Designer:		Drawing Title: RYM02MB_SCH_VA0311		
Drawn by:		Page Title: ?		
Approved:	Size	Document Number	Stage marker	
	A3	SCH-XXX PDF:SPF-XXX	S	
Date: Friday, March 11, 2022		Sheet: 14 of 19 Rev: S02

Hardware Department			
Designer:	Drawing Title: RYM02MB_SCH_VA0311		
Drawn by:	Page Title: ?		
Approved:	Size: A3	Document Number: SCH-XXX PDF:SPF-XXX	Stage marker: S
Date: Friday, March 11, 2022	Sheet: 15 of 19	Rev: S02

Hardware Department			
Designer:	Drawing Title:						
Drawn by:	Page Title: ?						
Approved:	Size	Document Number			Stage marker		
	A3	SCH-XXX PDF:SPF-XXX			S		
Date: Friday, March 11, 2022		Sheet: 13 of 19		Rev: S02

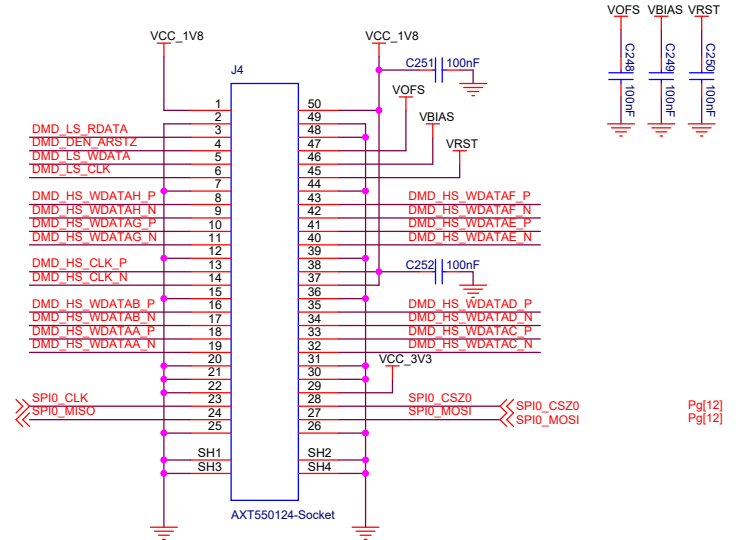
这块顺序故意反的，因为DMD那端接反了

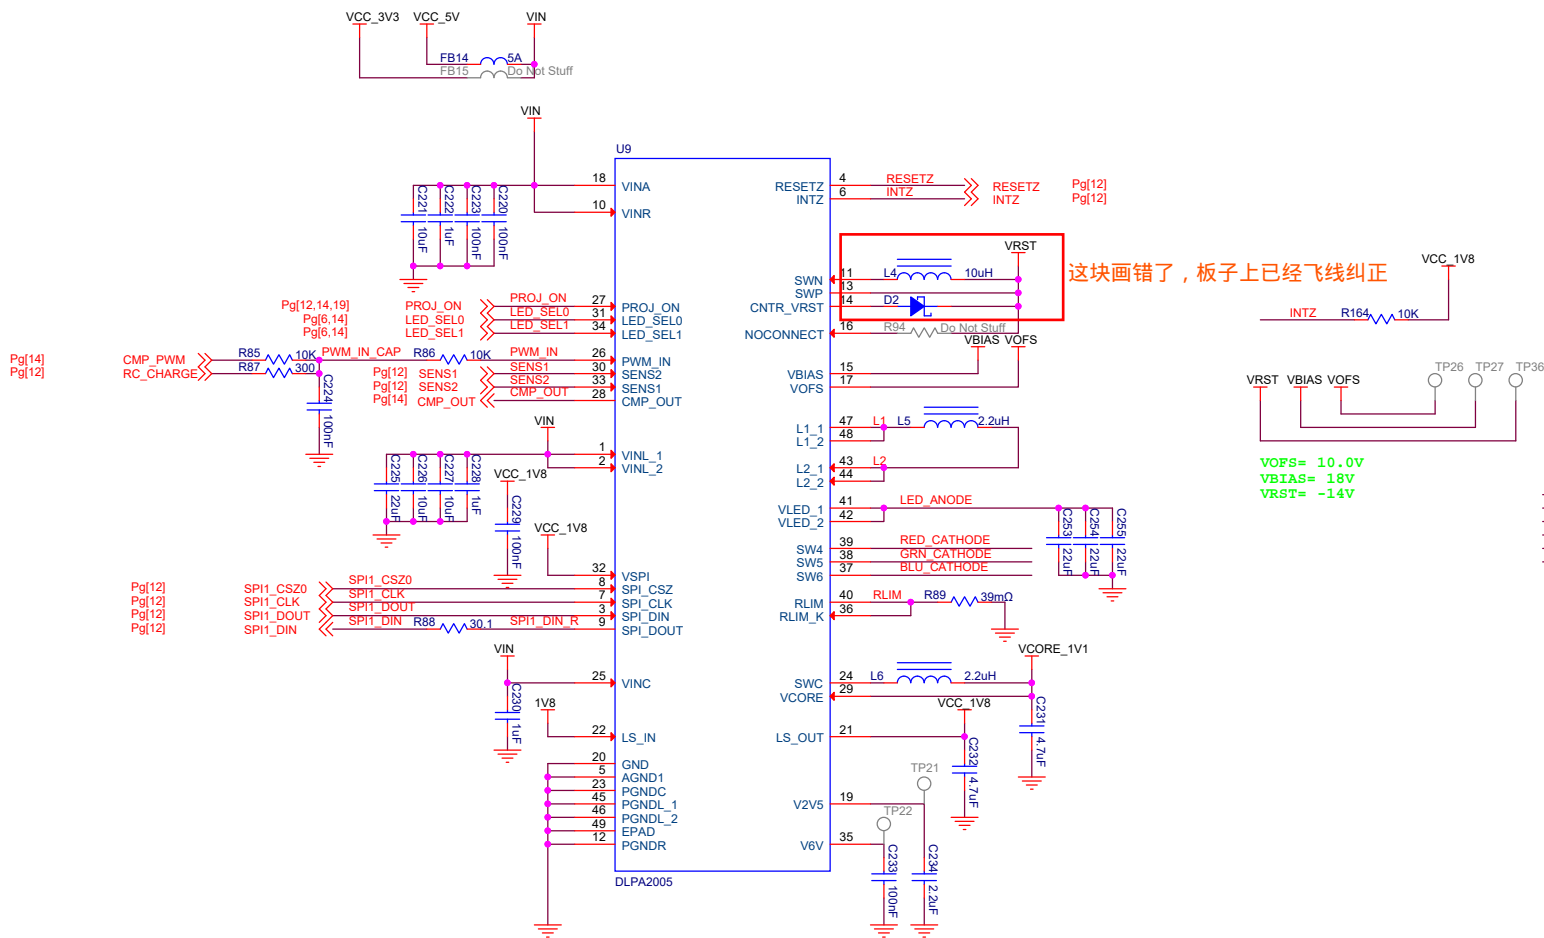
这块画错了，板上已经飞线纠正
